IN REPLY REFER TO:
NCPC FILE No. Z.C. 14-13

RE: NCPC Staff Comments on ZC 14-13, Text Amendments to Rooftop Penthouse Regulations

ZONING COMMISSION
District of Columbia
CASE NO. 14-13
EXHIBIT NO. 65
ZONING COMMISSION
District of Columbia
CASE NO. 14-13
EXHIBIT NO. 65

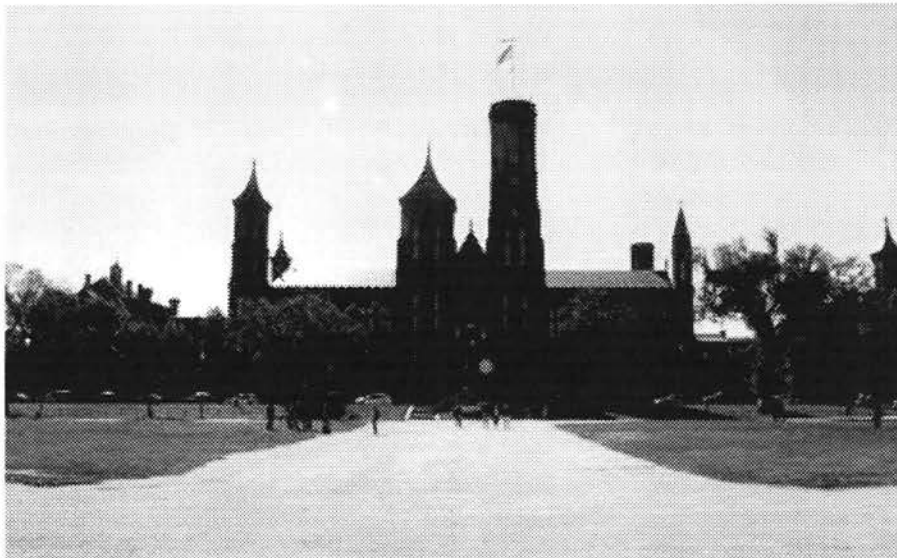
Based on this most recent application of square guidelines and the majority of buildings along the Avenue today, NCPC staff believes that penthouse related uses should be incorporated into the 160' building height, consistent with the overall guidance in the PADC plan.

NCPC staff proposes that no penthouses (both mechanical and habitable) be allowed on 160' buildings within the PADC boundary (squares fronting Pennsylvania Avenue between 3rd and 15th Streets, NW) unless otherwise allowed through individual square guidelines in the Pennsylvania Avenue Development Plan.

View of the Smithsonian Castle today from the center of the National Mall.

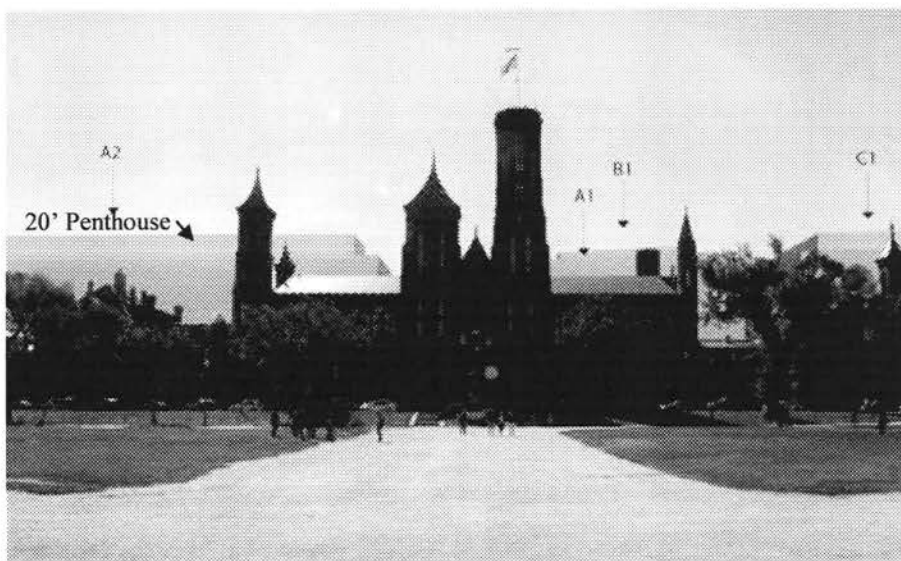
View of the Smithsonian Castle with new buildings at 130' in height with a 20' penthouse (total height of 150').

As previously indicated in staff's oral and written testimony to the ZC, any development over this 130' height (whether mechanical or habitable penthouses) would negatively impact the public open space views from the National Mall.

NCPC staff proposes that no penthouses (both mechanical and habitable) be allowed.² All rooftop equipment and mechanical structures should be incorporated into the 130' building. Any penthouse development over 130' negatively impacts views of the Smithsonian campus and views from the National Mall.
